Inspection Acceptance and Sign-Off Form

Project Name:	Hope Bay Project
Description of Area Inspected:	Doris North-North Dam Project: 5/8" Aggregate crush capping.
Date of Inspection:	January 20, 2012
Parties Present at Inspection	Mike Price Site Engineer; Nuna Logistics Ltd., John Kurylo EIT; Staff Consultant; SRK Consulting Inc. <i>Ben Vorstermann</i>

NOTES: - SEE JAN 20 th , 2012 CLEANING INSPECTION ACCEPTANCE FORM.		OWNER: NEWMONT NORTH AMERICA Hope Bay Mining Ltd.		PREPARED BY: NUNA Contracting Ltd. 9839 - 31 Avenue Edmonton, AB T6N 1C5		NORTH DAM CONSTRUCTION	
		PROJECT: Doris North Project, Hope Bay, Nunavut		DRAWN BY: RMM		DRAWING TITLE: Cut/Fill Map -Status of 5/8" Excavation to FCM	
				SCALE: 1:250	DATE: Jan. 17 2012	DRAWING NAME (YYMMDD): SM 120117 NORTH DAM 5-8 EXC.dwg

NOTES:	OWNER: NEWMONT NORTH AMERICA Hope Bay Mining Ltd.		PREPARED BY: NUNA Contracting Ltd. 9839 - 31 Avenue Edmonton, AB T6N 1C5		DRAWING TITLE: North Dam Alignment and Outline of Key Trench
	PROJECT: Doris North Project, Hope Bay, Nunavut				
			DRAWN BY: GC	SCALE: 1 : 1000	DATE:

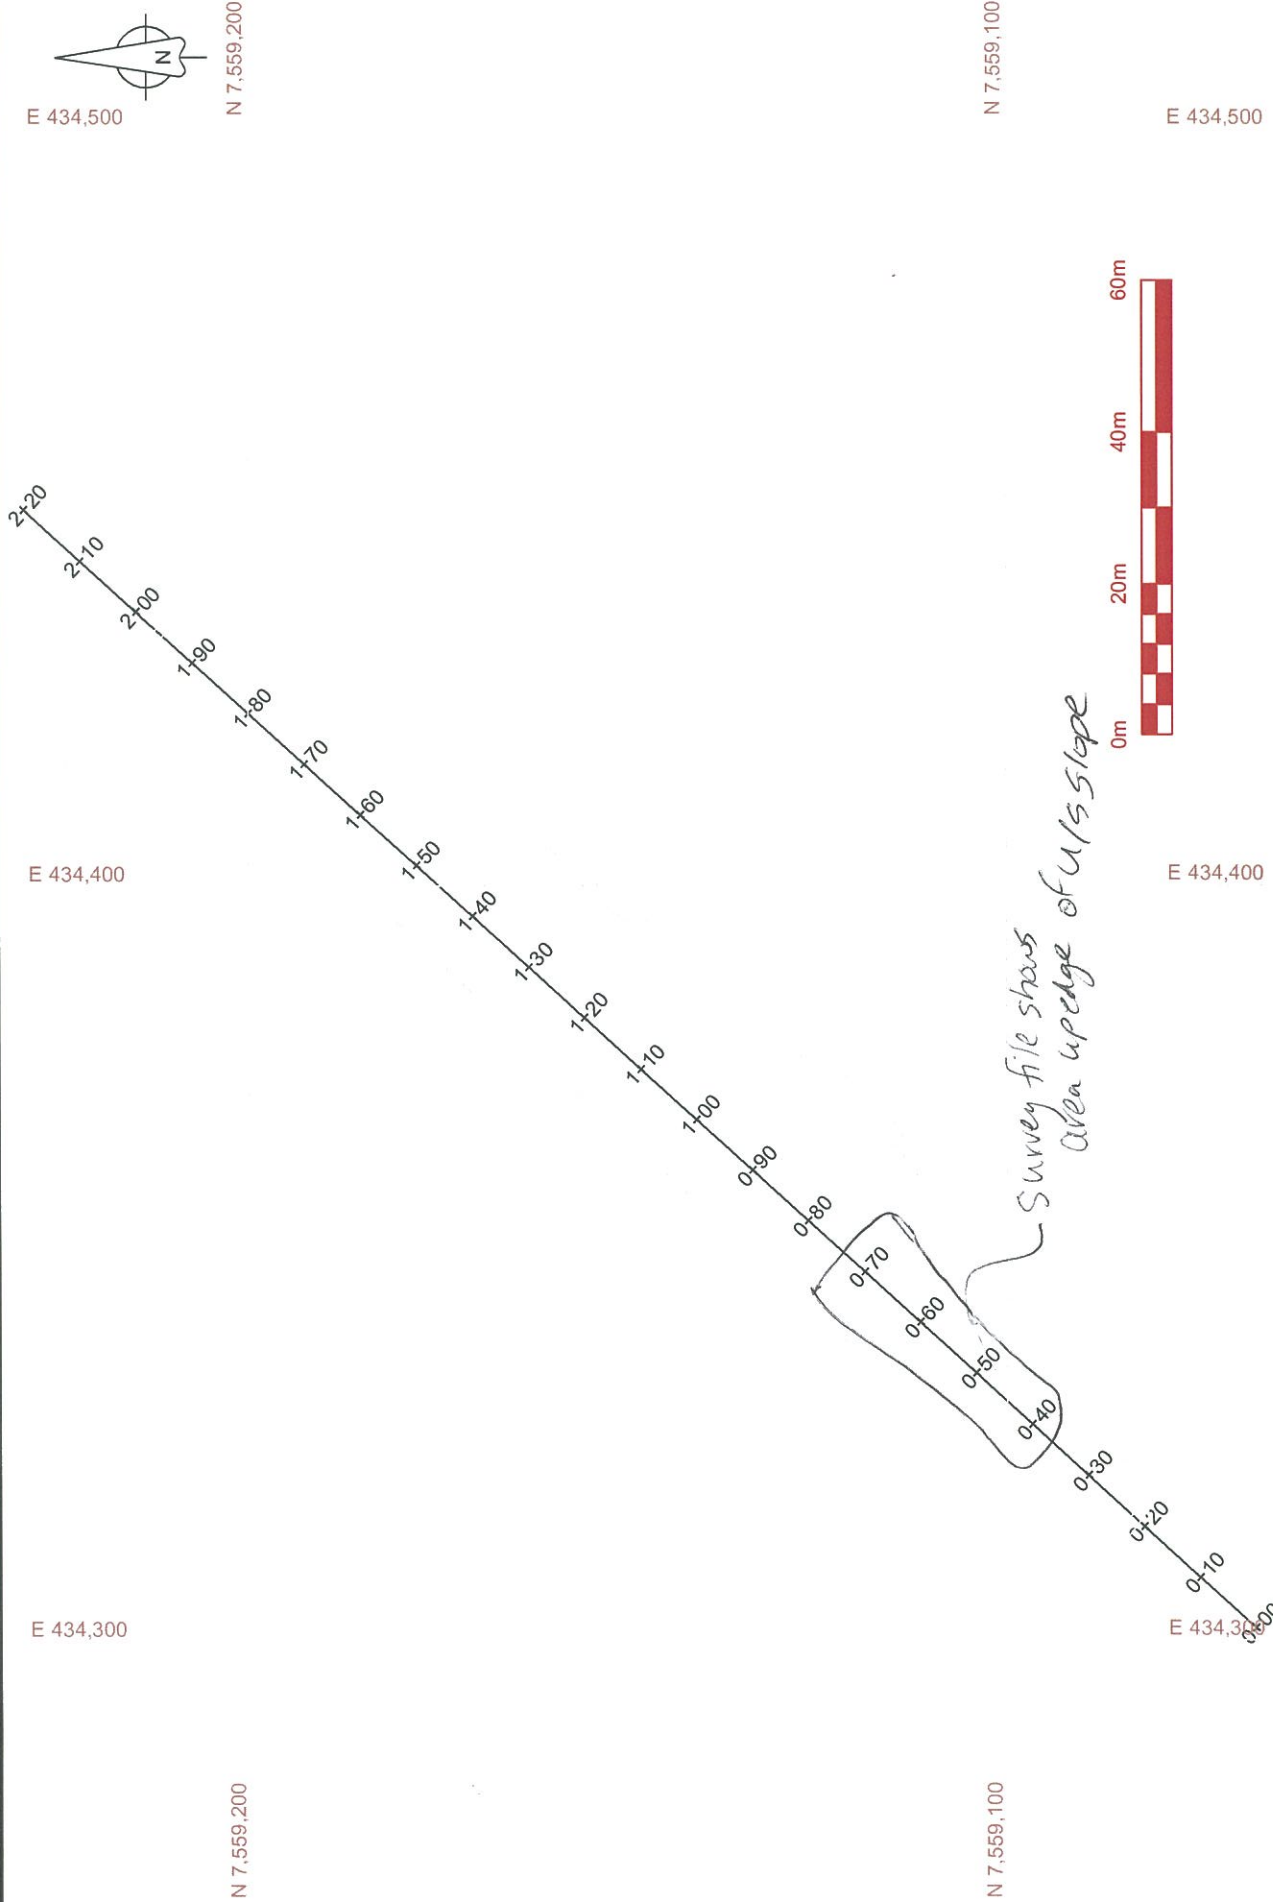
The designated "Dental cleaned" area has been found to meet the required engineering definition of cleanliness: free of snow, debris and ice build-up, and the previous placed lift has reached the desired temperature "Freezeback" for frozen core lift placement.

Placement has been approved for the section of the key trench between station 075 and 040.

See appended ^{Sketch}~~Survey~~ drawing for details of extent.

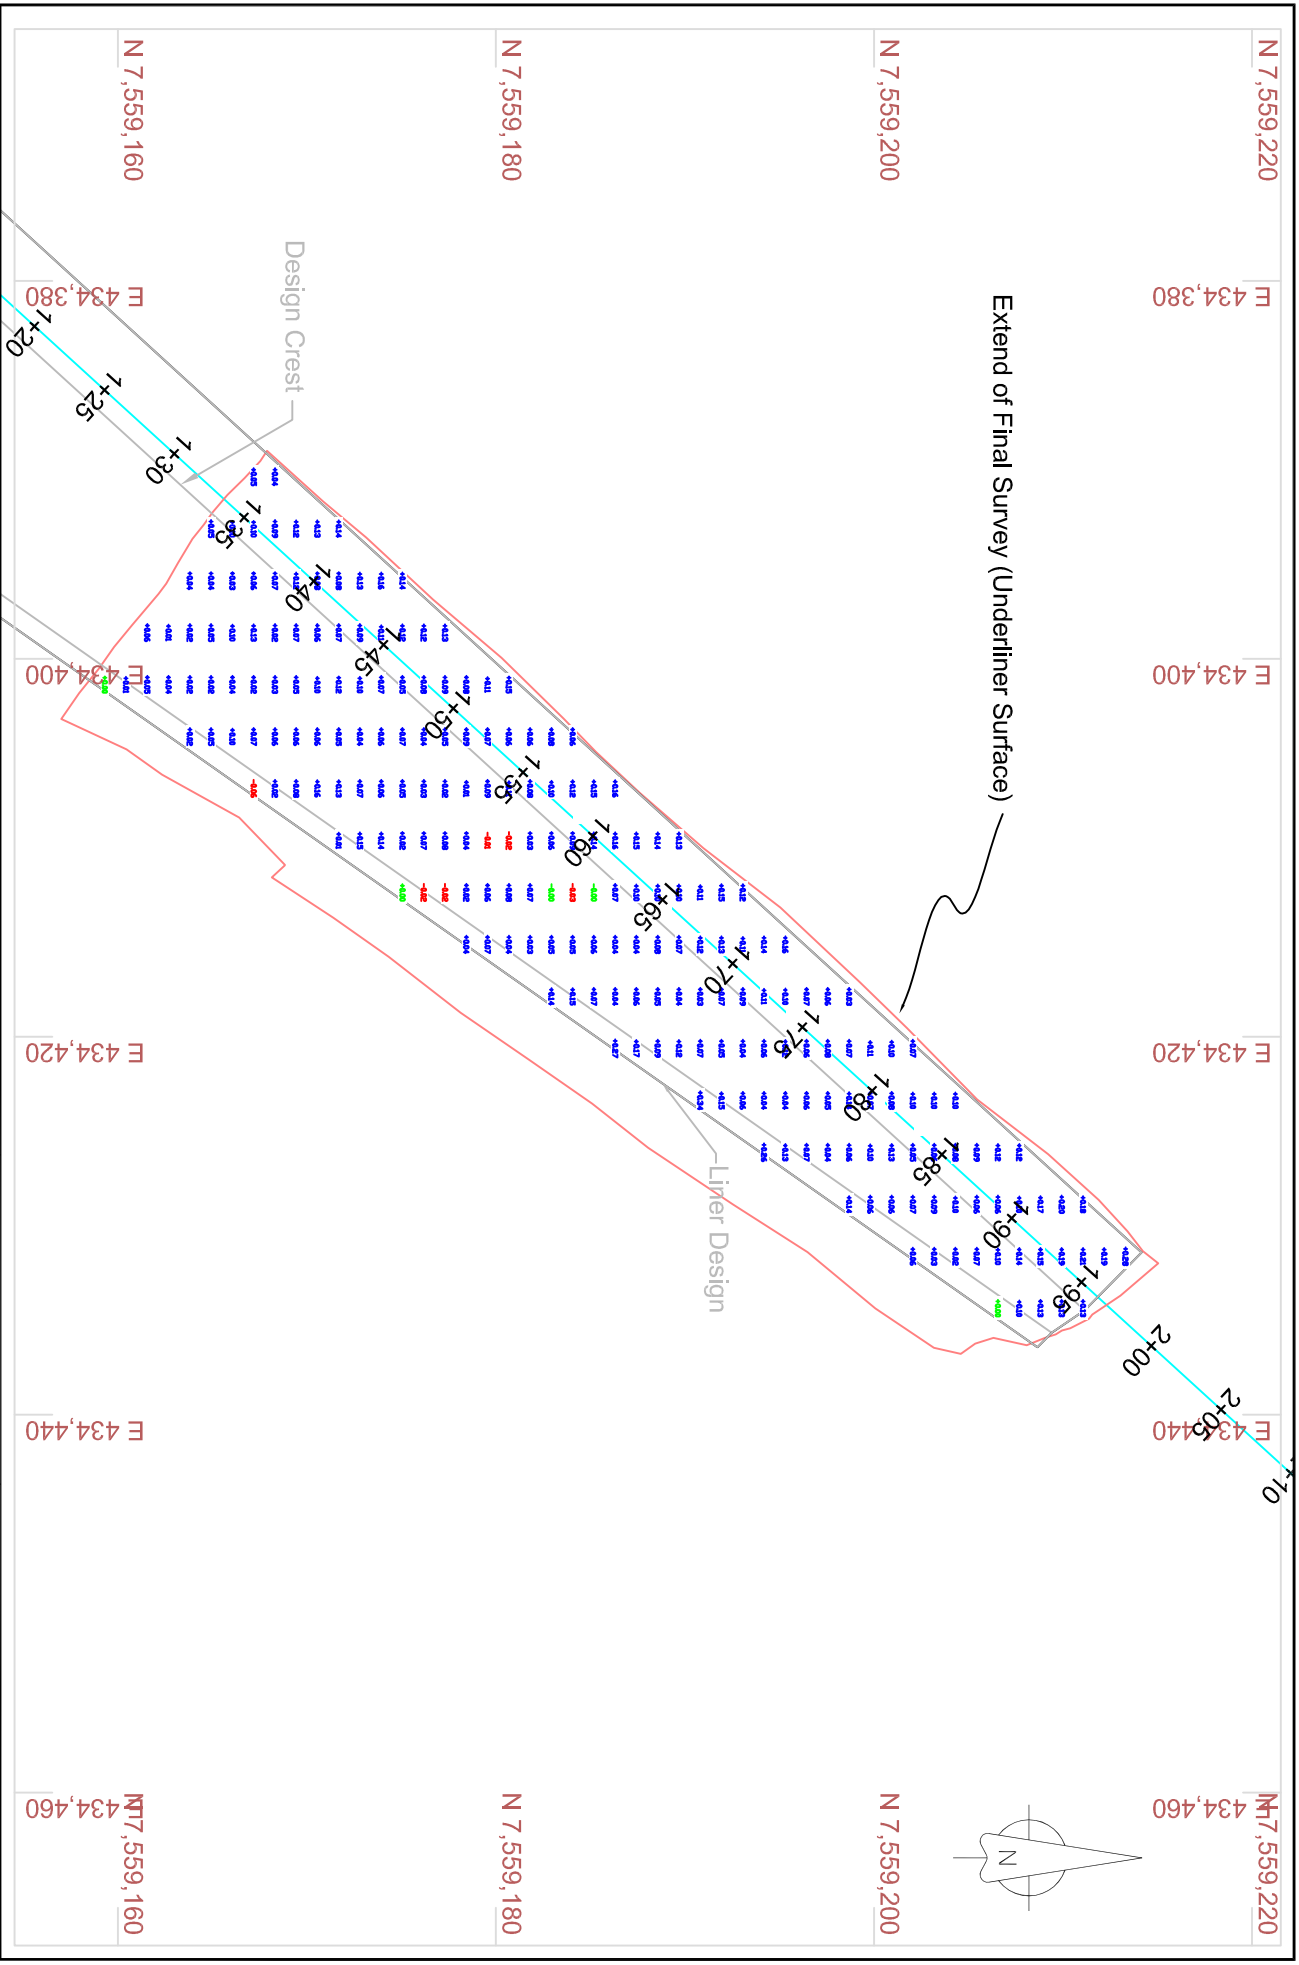
Comments:
<p><i>A visual inspection was completed of the core surface at the intended area of GCL installation. SRK confirmed that this was found to be acceptable for liner installation.</i></p> <p><i>GCL liner from Station 1+91 – 1+50 installation was completed following the required specifications (as per JDS-RFI-001 for bentonite placement and SRK tech spec for minimum overlap requirements)</i></p> <p>Note: See appended Survey drawing for details of extent.</p>

DRAWING TITLE:
North Dam Alignment and
Outline of Key Trench

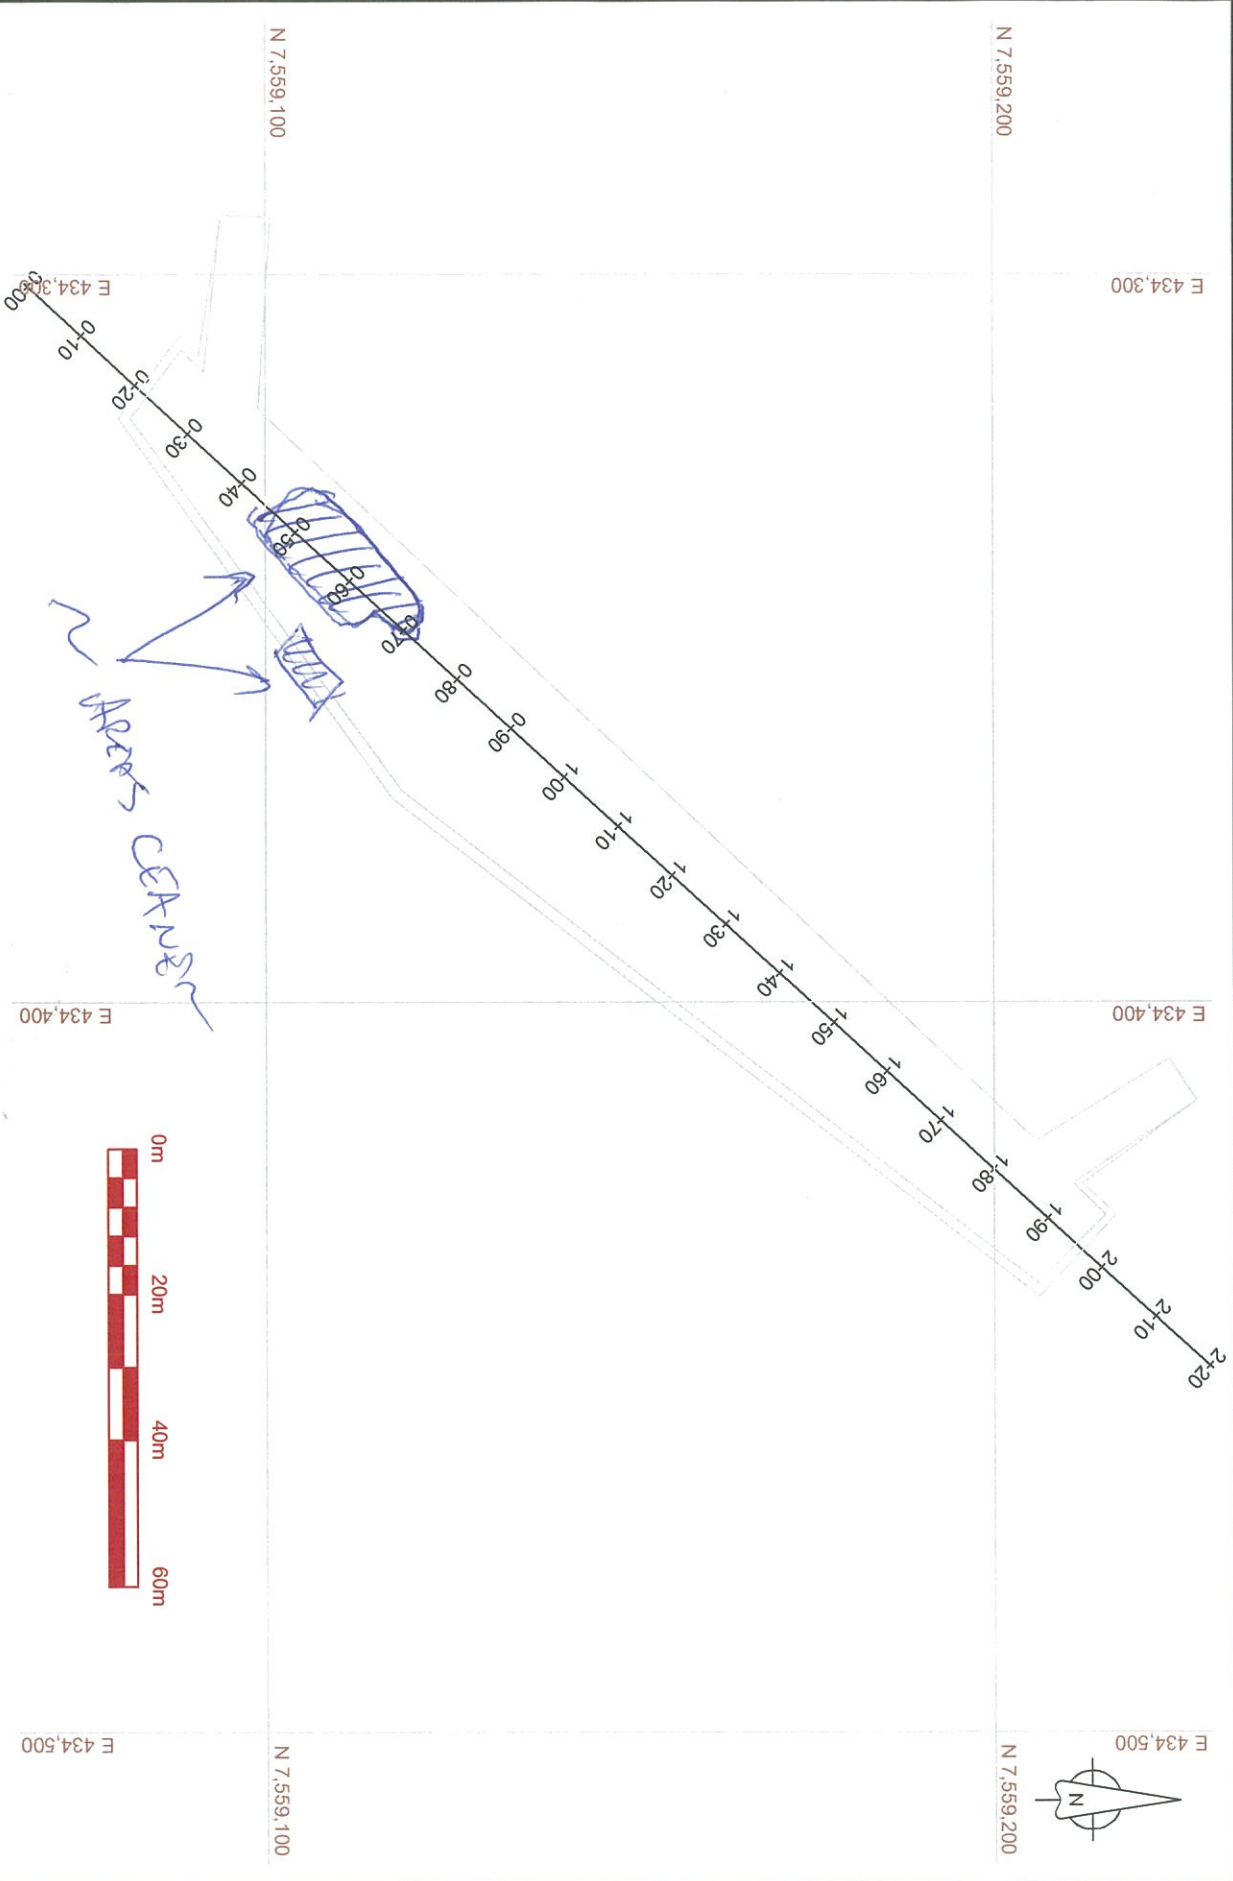
NOTE: SMALL AREA NEAR HINGE OF GCL ALSO CLEANED. SEE MAP. APPROVED TO PROCEED
See appended sketch drawing for details of extent.
